## **Access Compliance Report Public Rights-of-Way** (Pedestrian Signals)

ADA ID: 29C0EB56360A Signal Type: One Push Button-APS **Overall Compliance: No** Severity Score: BTN 1:N/A BTN 2: N/A No BTN: N/A

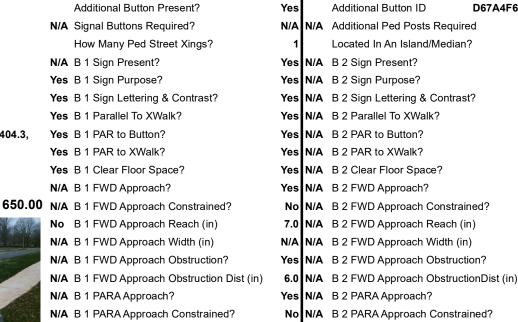
PROW/ADA: TMUTCD 4e.08, R404.2, R404.3, R406.2, R209.1, MUTCD 4e.10

Possible Solutions: Replace Signal Push Button With APS Button on New Post. Remove & Relocate Sign.
